SB-001

Service Bulletin

INSTALLING MODIFICATION WORK ORDER MWO-01/02 ON THE DTI-100A DF BEARING SYNTHESIZER

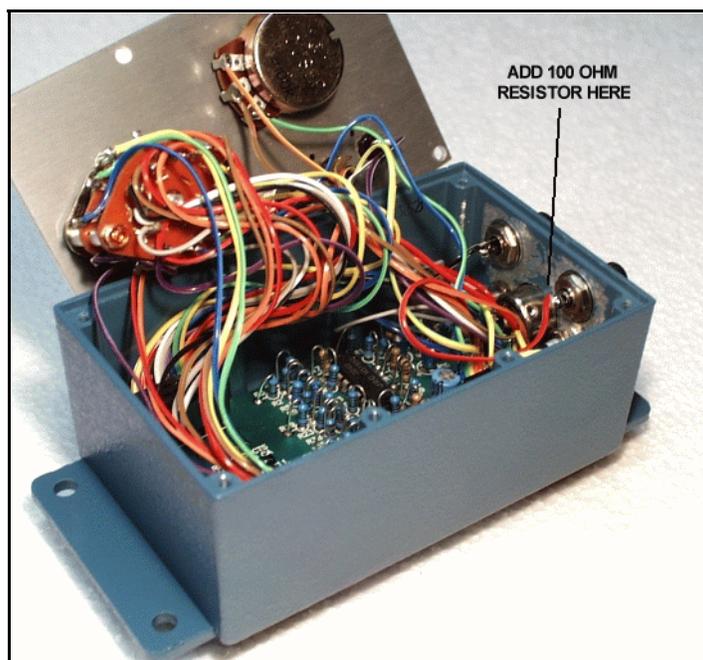
A problem has been identified with the DTI-100/DTI-100A DF Bearing Synthesizer whereby a direct short-circuit to ground from the **HIGH AUDIO OUT** phono connector can result in damage to the output tone amplifier. Although the problem appears not to occur in most units, it nonetheless warrants general corrective action.

The required corrective action is embodied in Modification Work Order MWO-01. MWO-01 is a simple procedure whereby the DTI-100A is modified by adding a 100 ohm resistor in series with the **HIGH AUDIO OUT** connector. This procedure is presented below.

- 3__ Unsolder the red wire from the **HIGH AUDIO OUT** phono connector (see illustration) and clear excess solder from the connector pin hole.
- 4__ Obtain a 100 ohm 1/4 watt 5% carbon film resistor and trim both leads to 1/4". Using a long-nose plier, bend a hook in each lead.
- 5__ Place either lead of the 100 ohm resistor through the connector pin hole and then solder the lead to the pin.
